Vertical circulation refers to how pedestrians and bicyclists are able to move from the bridge level to the street below, in this case to Market Street north of the railroad near the Pavilion. Three options are being explored:

OPTION 1 – STAIRS ON EAST AND WEST SIDE WITH MEZZANINE CONNECTION

OPTION 3 – STAIRS ON EAST SIDE WITH MEZZANINE CONNECTION

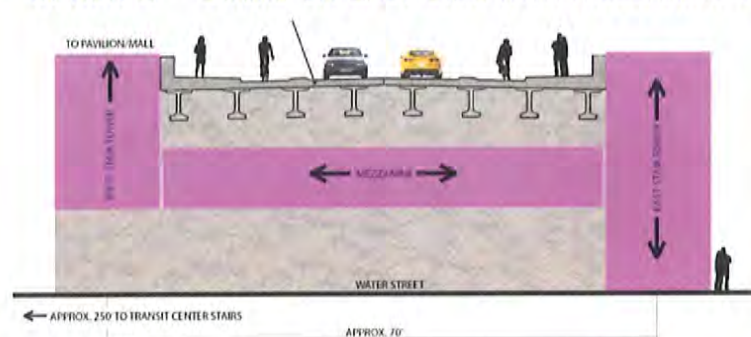
ADD ADA ramp?

OPTION 1 – STAIRS ON EAST AND WEST SIDE WITH MEZZANINE CONNECTION

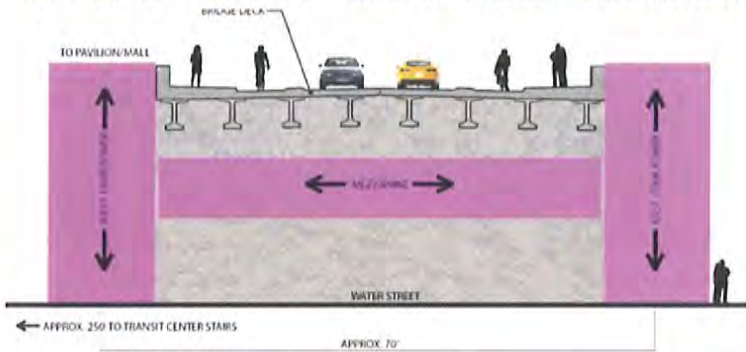
Can there be a ramp?

OPTION 1 – STAIRS ON EAST AND WEST SIDE WITH MEZZANINE CONNECTION

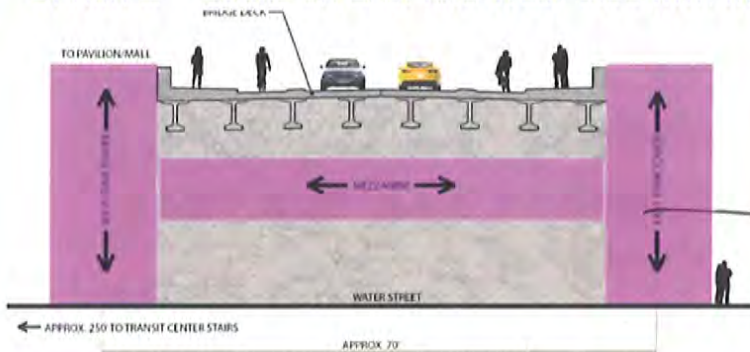
only saves you from walking up or down a single flight. Not necessary.
